**Sent:** 12/06/2023 10:25:07 PM  
**Subject:** Development Application DA2023/0617 – Submission to Council  
**Attachments:** DA2023\_0617 submissionvF.pdf;

### **Development Application DA2023/0617 – Submission to Council**

I am writing to formally object to the development application 'DA2023/0617' lodged with the Northern Beaches Council on 24/05/2023. I am deeply concerned about the proposed development at Lot 6 & Lot 7 DP 9585 22 & 24 Angle Street Balgowlah, which demonstrates significant non-compliance with existing planning controls and is not compatible with the surrounding properties.

[Plans – Master Set ‘Ground Floor Plan’ p.3 with annotations]

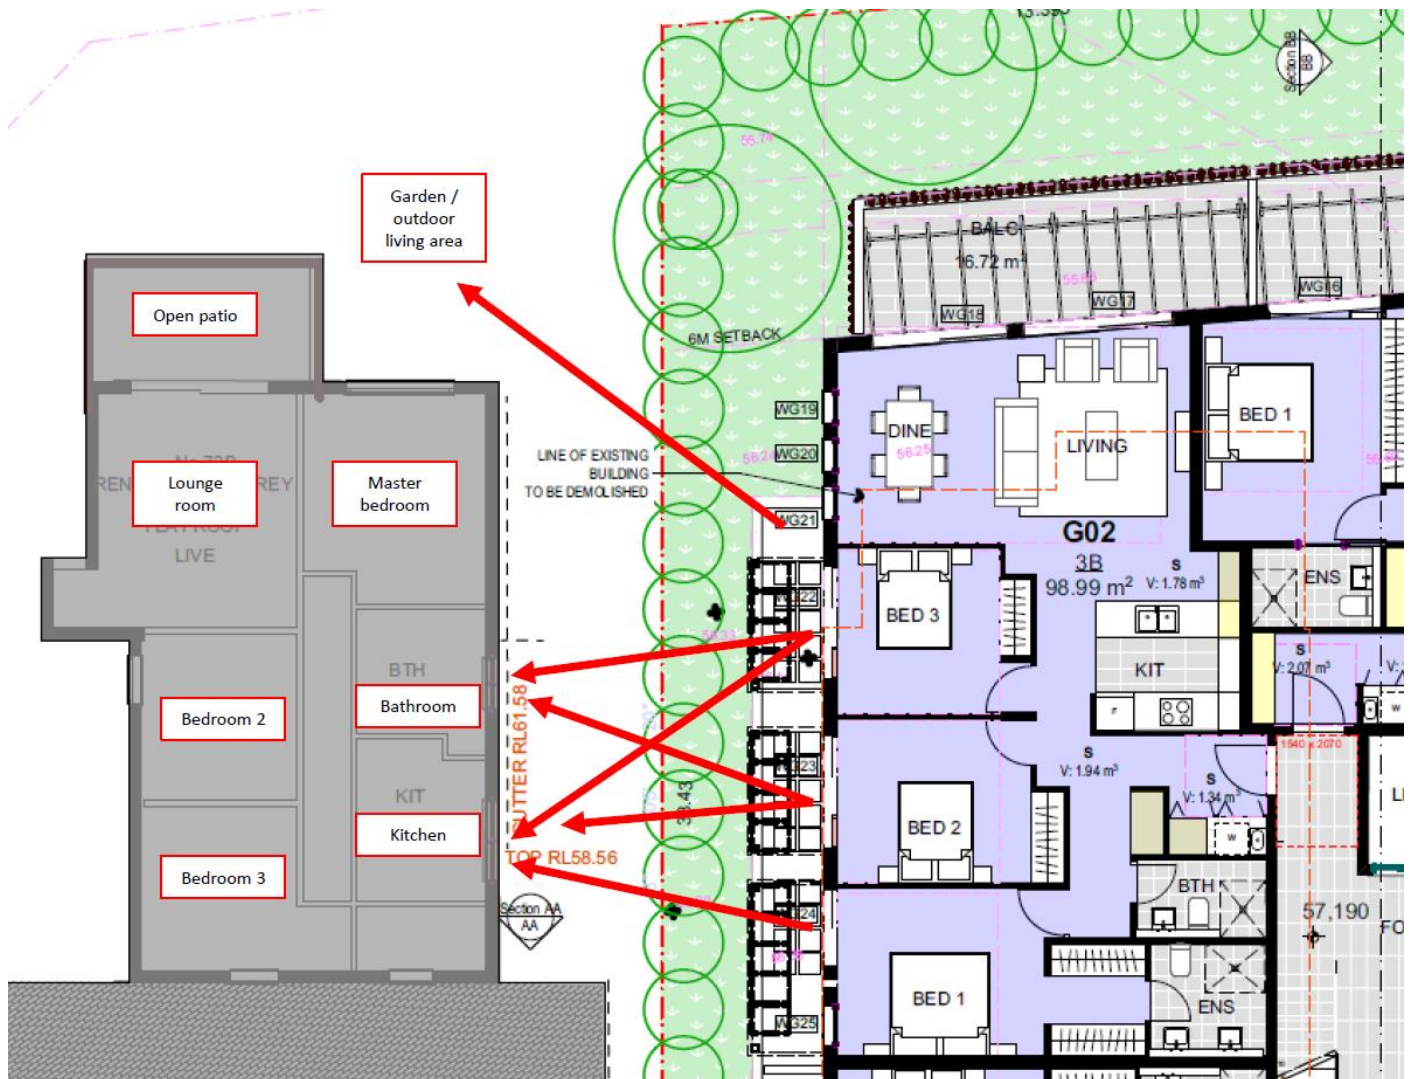
The basement carpark structure protrudes approximately 1.2m above natural ground level at the north elevation adjacent to the western boundary [Plans – Master Set ‘Elevations 1’ p.6]. This structure is well within the required 3 metre setback from the western boundary.

The balconies on the western elevation of the proposed development sit atop the basement carpark and are located well within 3 metres of the western boundary. As a consequence of these balconies being elevated 1.2m above natural ground level (and above ground floor level at 72B West St) the impact on the privacy of neighbouring residents is more intrusive both visually and acoustically than otherwise would be the case. This is shown in the Ground Floor annotated plans below.

3. Ensure full compliance with the required setbacks [Manly DCP 2013] particularly on the western elevation, to protect the privacy of neighbouring properties. Improved screening measures and increased landscaping and open space should also be enforced to mitigate privacy (visual and acoustic) impacts.

[Plans – Master Set ‘Level 1 Plan’ p.4 with annotations]

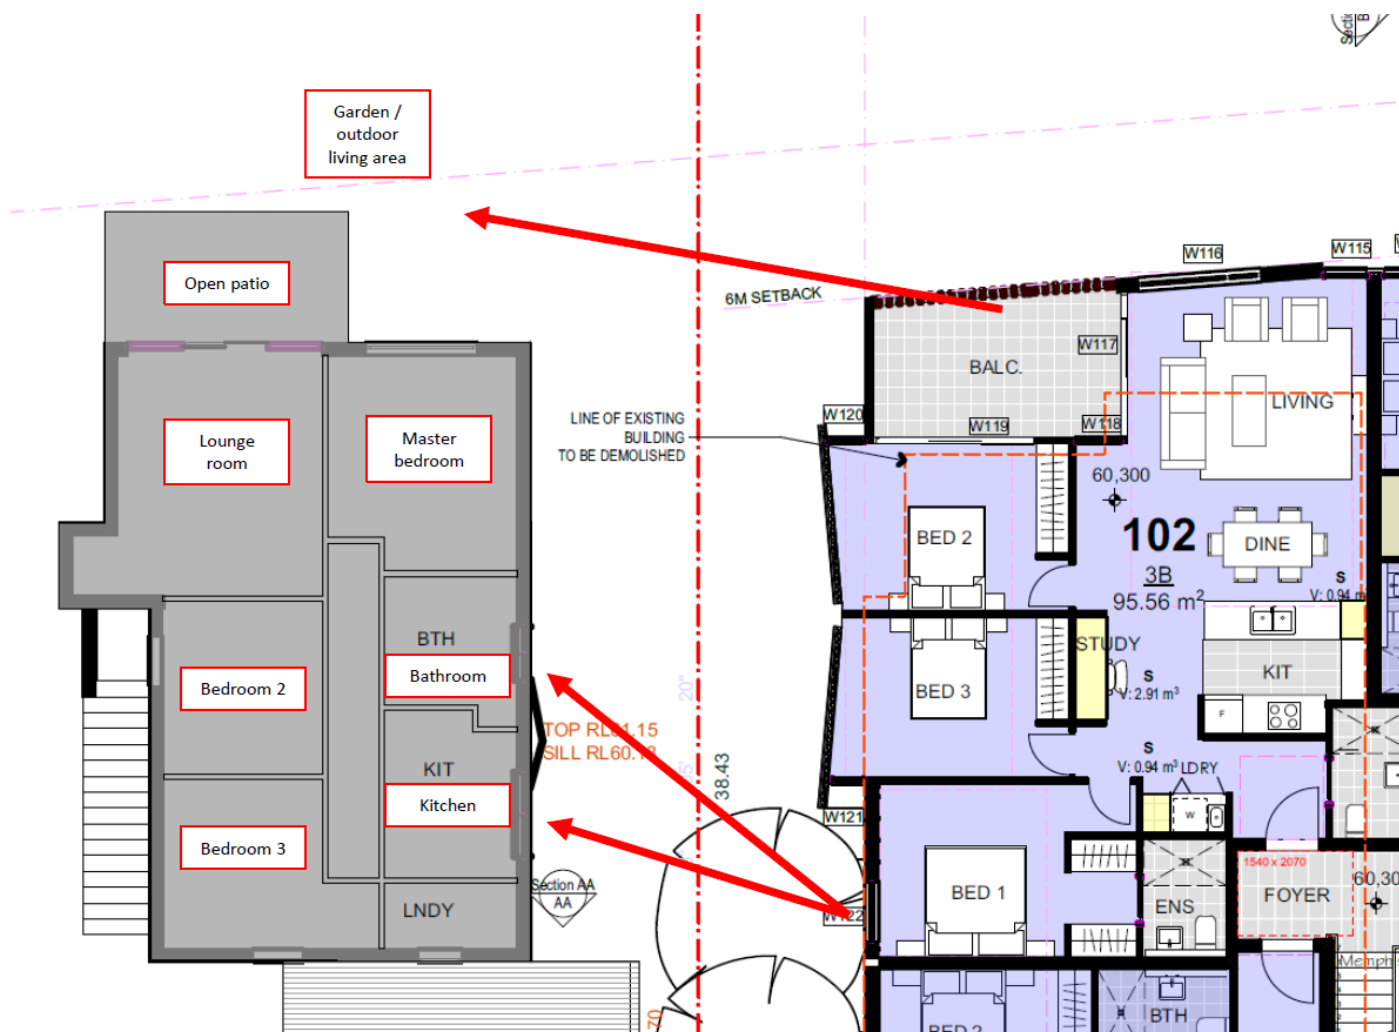
On Level 1, the articulated architectural element (being the external cladding and windows) on the western elevation is within the required 3 metre setback from the boundary. This non-compliance impacts the neighbouring properties' privacy at 72A and 72B West St by increasing the proximity and associated impact of overlooking

windows. It infringes upon the residents' right to privacy and enjoyment of their own homes. This is shown in the Level 1 annotated plans below.

On the western elevation of the proposed development, the Unit 102 bedroom #1 and Unit G02 bedrooms #1, #2 and #3 in directly overlook the kitchen and bathroom windows of 1/72B West Street. This conflicts with the statement by Wolski Coppin Architecture on p.3 of their Design Verification Statement (Annexure A) used to justify the non-compliant setback stating, ***“the setback to the west is appropriate due to the neighbouring blank wall and thus there is minimal loss of amenity for neighbouring residents”***. For the avoidance of doubt there is no “blank wall” on the existing adjoining property. This is shown in the Ground Floor and Level 1 annotated plans below.

At the northern elevation, the Unit 102 balcony overlooks the open patio and principal outdoor living area of 1/72B West Street, significantly impacting the privacy and amenity of existing residents. This is shown in the Level 1 annotated plans below.

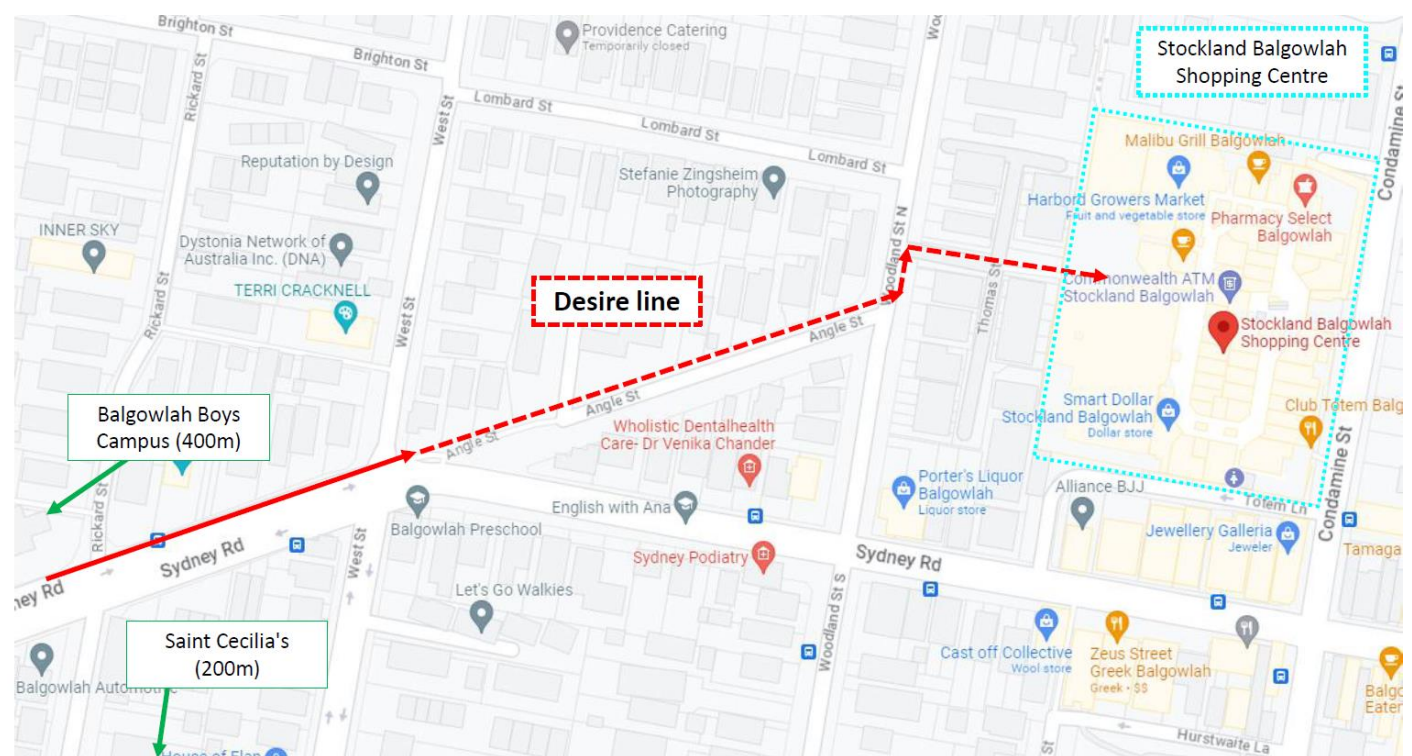
The proposed landscaping on the western elevation is seriously compromised and likely ineffective due to:

- Lack of solar access along the western elevation with the excessive size of the building footprint, and the non-compliant building separation and setback; and
- Insufficient width available within the setback for any substantial planting along the western boundary (<1 metre wide) with the basement carpark structure and balconies encroaching, and provision of an access pathway along the western boundary.

7. Enforce compliance with the minimum residential open space and minimum landscaped area requirements, and ensure that landscaping along the western elevation has sufficient width, solar access and soil area for substantial planting.
